RE: **SAD 227 lot 6-A Block 12, Volcano Cliffs Unit 5**
6520 Jade Dr. NW
Grading and Drainage Plan
Engineers Stamp Date 8/17/2017 (E10D032)
Rev. Grading Plan Date: 3/30/2022

Drainage Report Update 3/16/2022

TITLE:
6520 JADE DRIVE NW
GRADING & DRAINAGE PLAN
UPDATED GRADING FOR POOL ADDITION

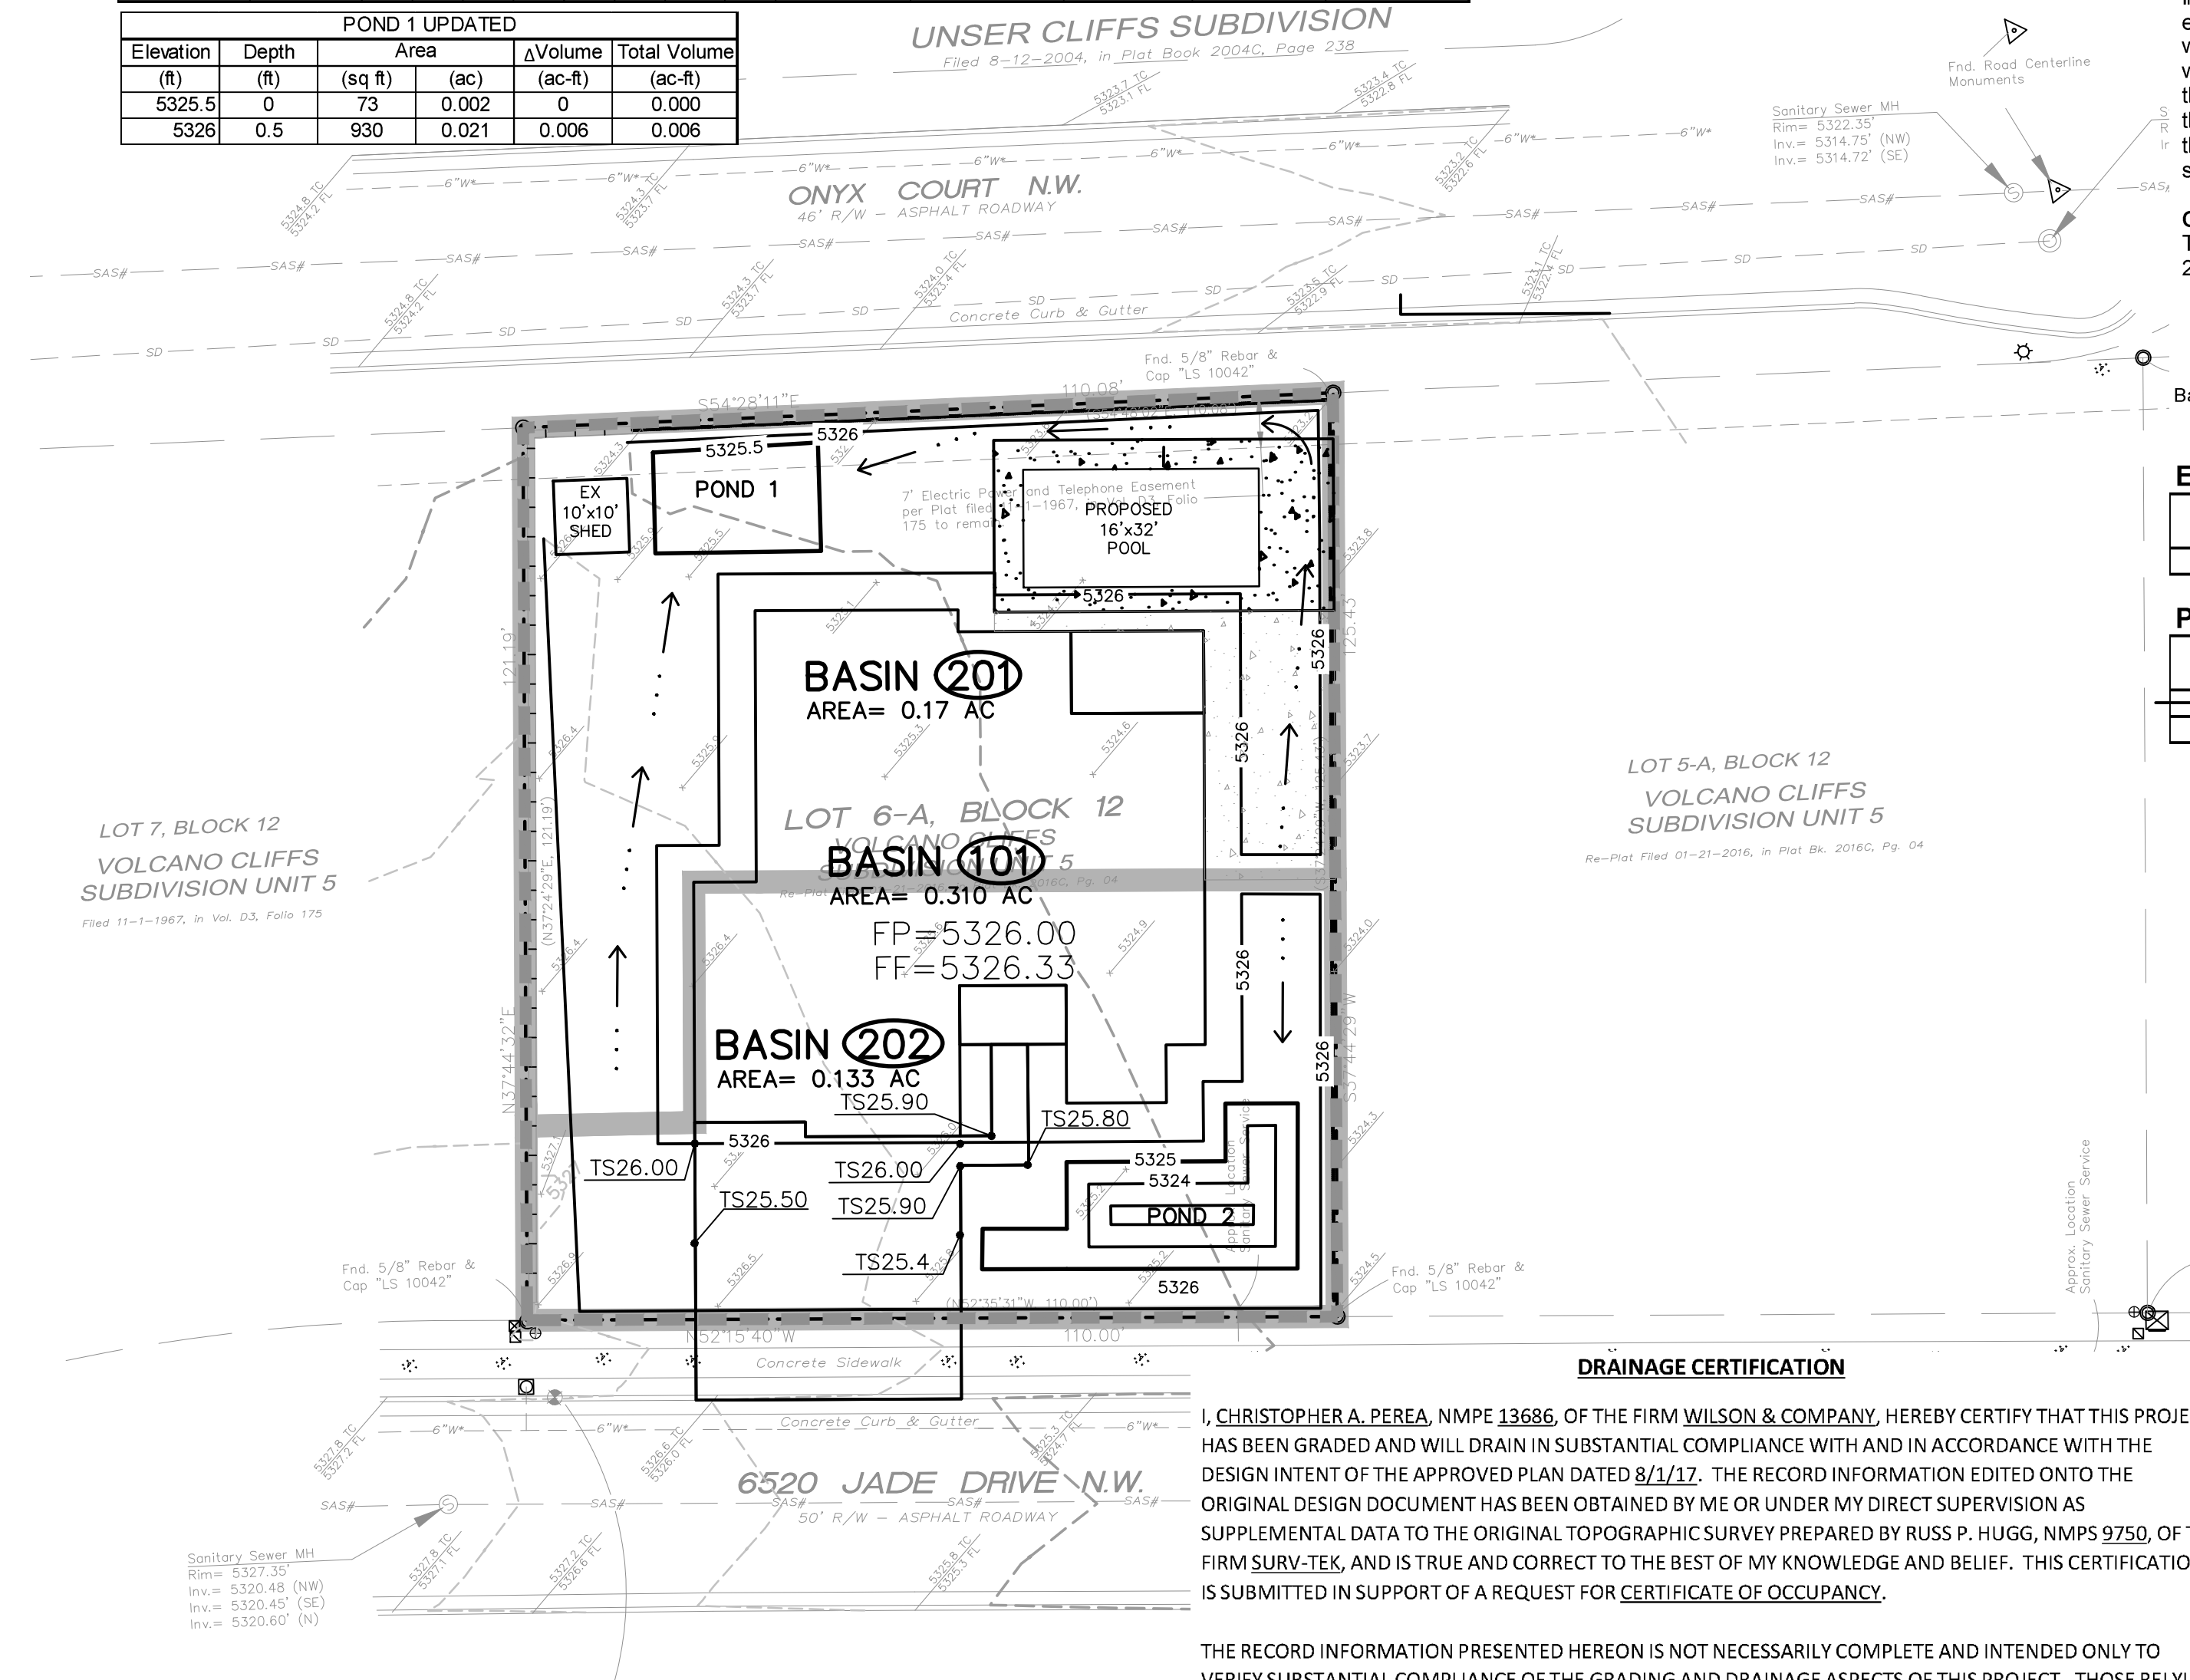
Based upon the information provided in your submittal received 3/30/2022, this revised plan is approved for Grading Permit. Please attach a copy of this approved plan to the construction sets in the permitting process prior to sign-off by Hydrology.

Make sure the contractor and owner know not to use dirt as a ramp to climb the street curb, either use lumber or crusher fines for this purpose.

Prior to Certificate of Occupancy release, Engineer Certification per the DPM checklist will be required.
